Please find my comments about the paper referred as HESS 11- 5953-2014 by Atkinson et al.

General comments:

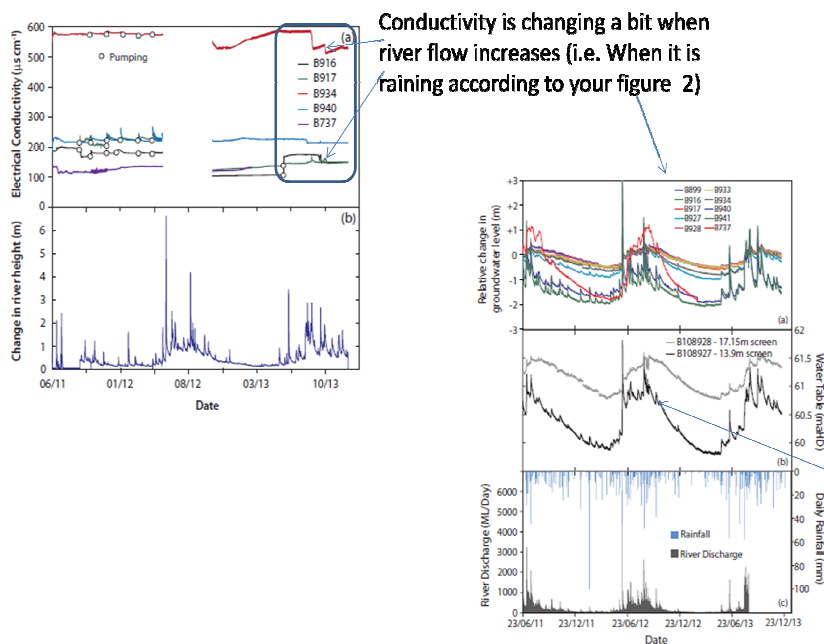
P 5962: "Ca and O_4 (Fig. 3d)". a S is missing for SO_4

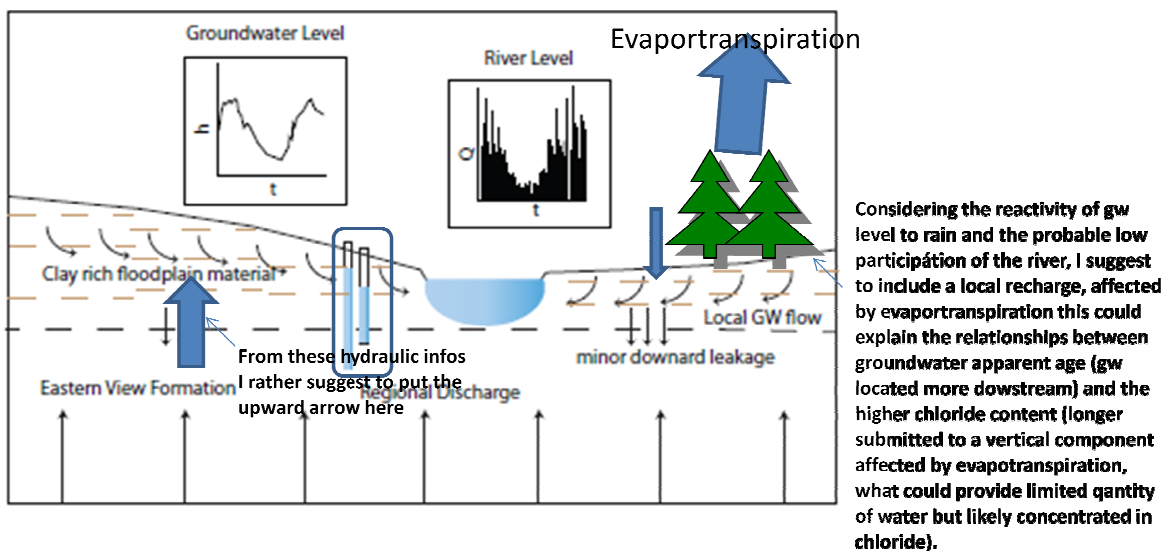
There are some contradictory clues that you need to solve (or that you need to discuss). If I summarize, you show that groundwater levels is sensitive to rainfall rate, including the water level in the regional groundwater flow system. When looking at the EC, you said that " groundwater EC was constant throughout the study period and there is no inverse relationship to river height (Fig. 6). I am not totally agree as if you increase the scale, you can see that EC is moving especially at the end of your campaign. River height can be seen as a proxy of the rain rate and also of the groundwater rate, as you show in figure 2 that the gw depth are changing especially when rain rate increase.

Conductivity is changing a bit when river flow increases (i.e. When it is raining according to your figure 2)

Waters with apparent age of about 6000 years But reactive to rainfall increase.....

So my question is as following: How can one explain that gw presenting old recharge apparent age implying long transit time, can be so reactive to rain rate change?
